INFORMATION BULLETIN

Subject	Shunt Harness Retrofit from 022574 to 039512
Issue Date	10/24/23
Service Bulletin Number	IB-23-132
Models Affected	Service Specified Vehicles
Complete By	Next Service Opportunity
Labor Operation Code	HA43J
Description	Instructions to support customer when PN: 022574 is not available and PN: 039512 is required to be used in its place.

This retrofit updates the HVJB when replacing shunt PN: 022574 to PN: 039512.

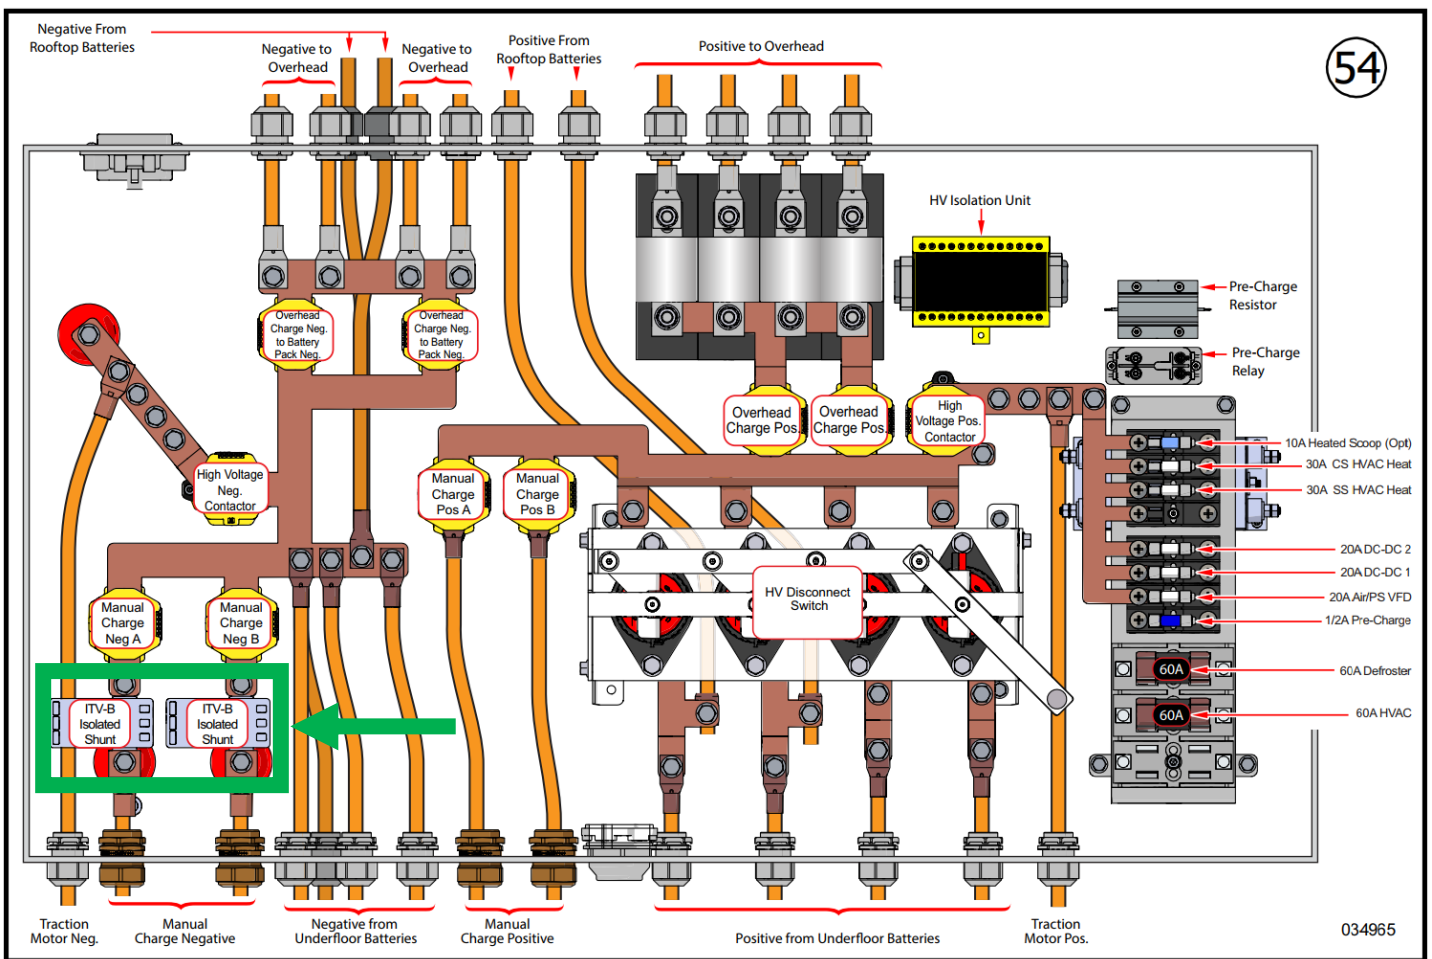
Locate the ITV-B Isolated Shunt to be replaced shown in the green box above.

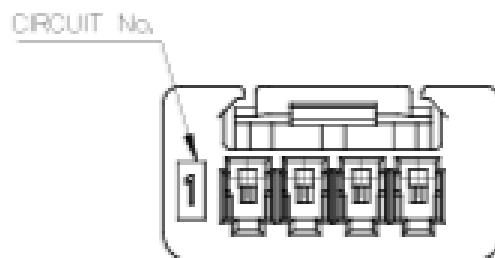
Terminate wires into positions below on the DuraClik Connector 4 Position (PN: 039689):

BLK wire into Position 1.

YEL wire into Position 2.

GRN wire into Position 3.

RED wire into Position 4.
